**I Michael Connelly of 15 Parkes Lane Terranora, wish to object to the development proposal No.09\_0166 - Residential subdivision, by Newland Developers (formerly Metricon Queensland) Pty Ltd on the following grounds:**

FIGURE 1

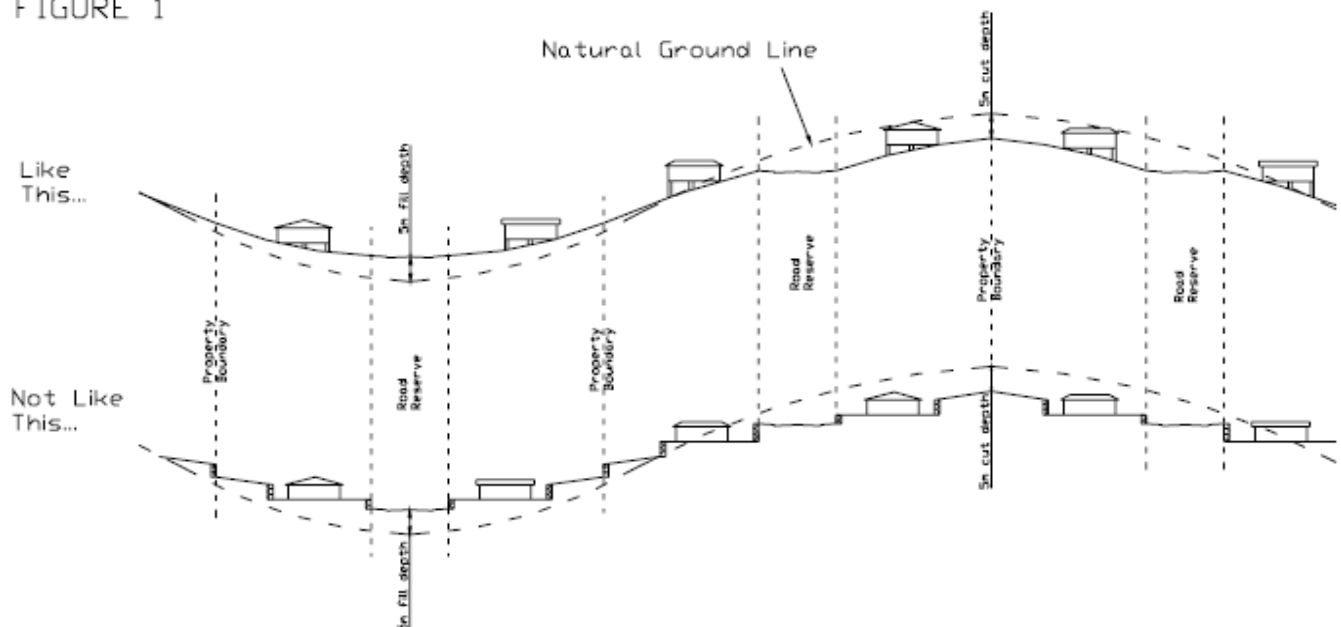
It should be noted that the Newlands development proposes the extensive use of terracing and retaining walls in an effort to achieve terraced lots, which is:

- in contravention to Tweed Shire Council landforming policy
- and totally out of character with the adjacent rural living estate

The preliminary retaining wall plan prepared by Brad Lees Consulting (SK2712) shows that almost every allotment has retaining walls on at least 3 of its boundaries. There is also a 3metre high retaining wall along the entire Fraser Drive boundary and two 3metre high walls on the boundary with properties in Parkes Lane creating an imposing 6metre high wall. As well as being in contravention to Council landforming policy, these walls will create a visual eyesore which has once again been ignored in the Visual Impact assessment prepared by LVO Architecture.
